TELEVISION TECHNICAL BULLETIN

MODELS 66GS62H

Reference SP021700X

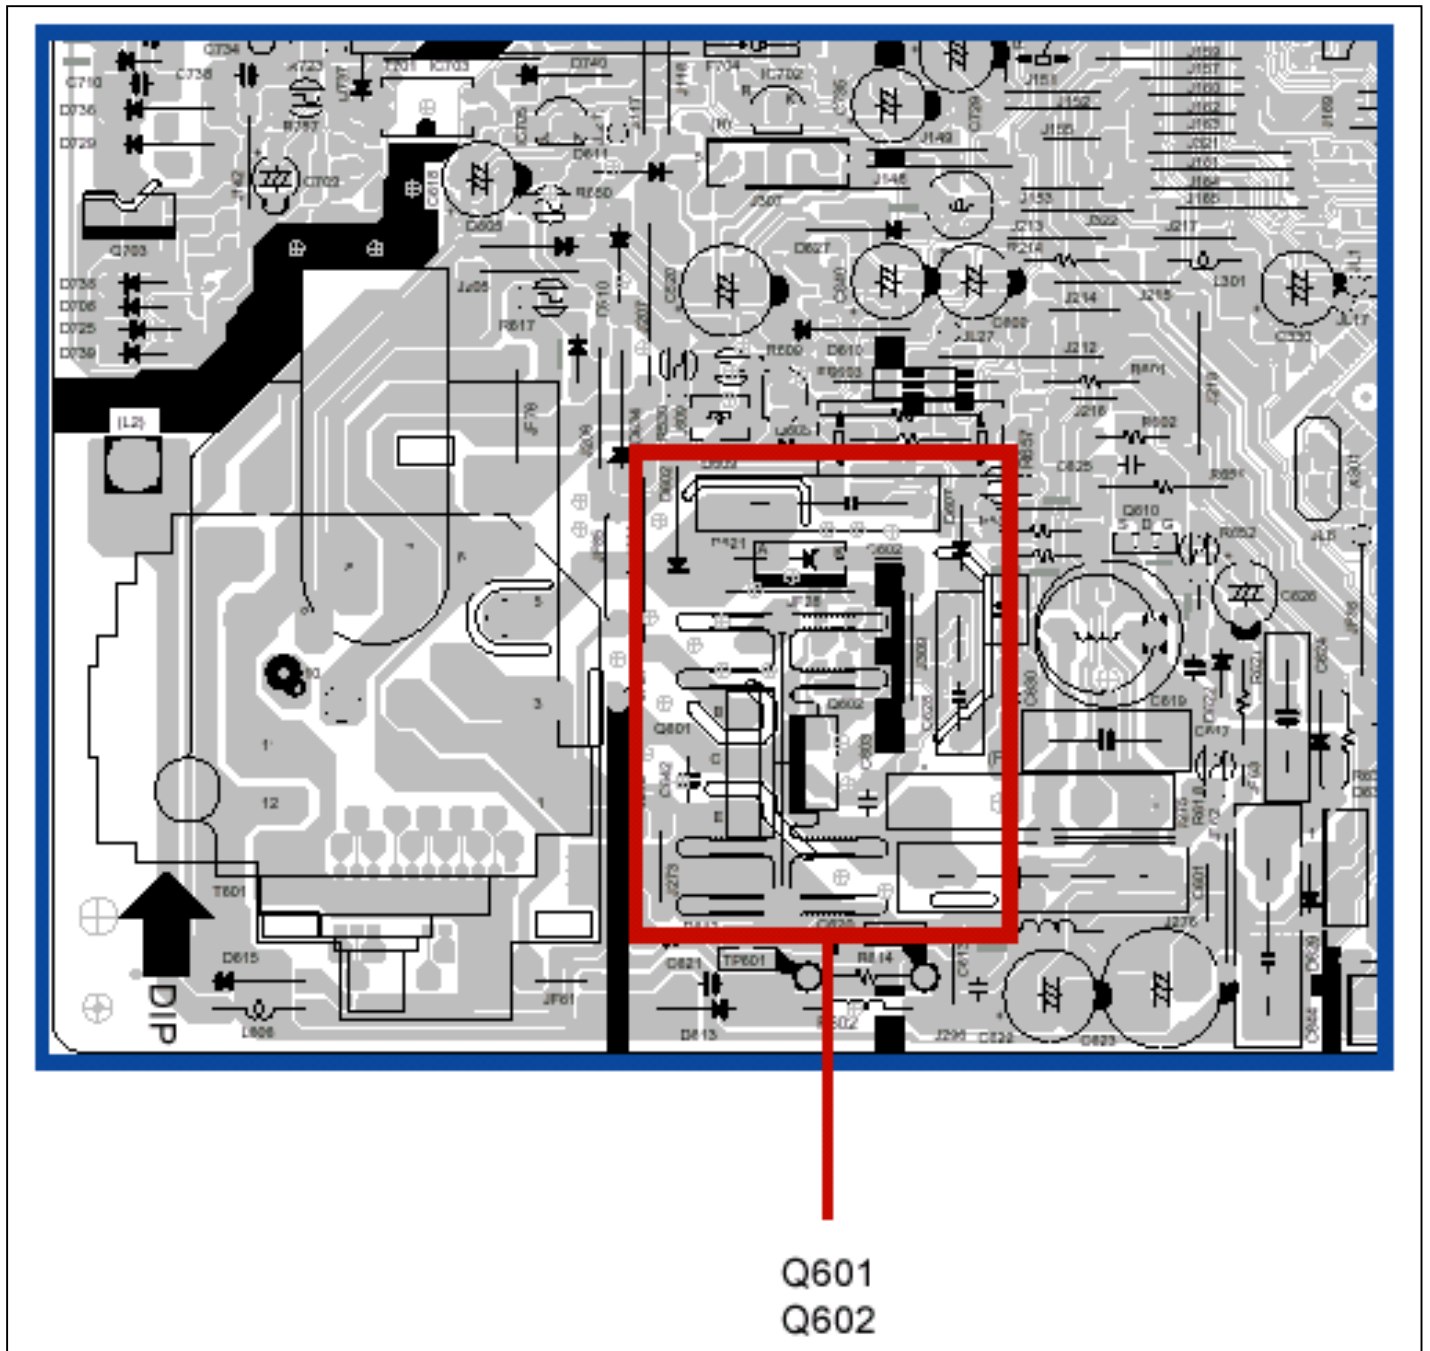
REASON Upgrade E/W transistor to improve reliability (Q602).
Change of Heatsink to reduce the operating temperature (Q601, Q602)

ACTION Change Q602 to RHTX0236BMZZ (2SK2843 600V Toshiba). Also replace the Heatsink of Q601/2 to PRDARA018WJFW (larger size) in order to reduce their operating temperature.

<u>REF NO</u>	<u>DESCRIPTION</u>	<u>PART NUMBER</u>	<u>PRICE CODE</u>
Q602	TRT 2SK2843 Heat sink set	RHTX0236BMZZ PRDARA018WJFW	AE AC
